## Service Bulletin

Reference Number	NBP-0001
Date	4/5/2018
Product	Vacuum Pump
Affected Models	NPR6Di & NPR8Di

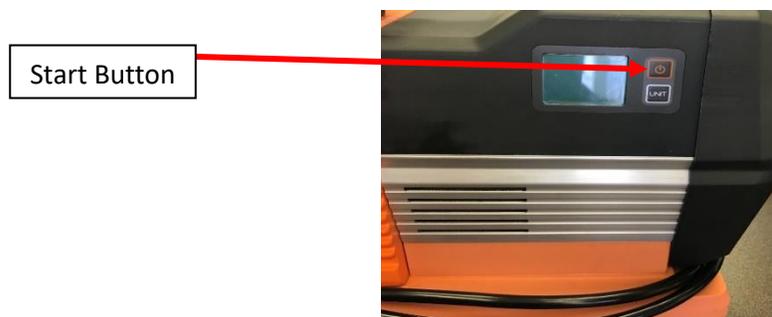
As part of the design in the NAVAC Intelligent Pump, it was intended to notify the operator when the evacuation process is complete. The pump will alert the operator 30 minutes after reaching 500 microns that the evacuation is complete and run at a reduced speed.

**Issue:** In certain applications, in particular to long evacuation periods or situations requiring a deeper vacuum, it may be convenient to disable the constant beeping alert from the pump 30 minutes after reaching 500 microns and keep the pump running at High Speed

**Solution:** After the alert starts to beep, the pump will slow down, you can turn off the pump by pressing the “Start Button”  then turn the pump back on. The alert will turn off and the pump will run at **High Speed**.

\*\*\* **Note:** This can only be disabled or enabled once the pump starts beeping.

If you would like to **Disable the alert before running a vacuum on your system**, you will need to run the pump with valve caps on and tightened. After 30 minutes, the pump will beep, then you can disable it by pressing the “Start button”. **DO NOT TURN POWER ROCKER SWITCH OFF**. Turning the power off or unplugging it will reset the condition back to beep alert mode.
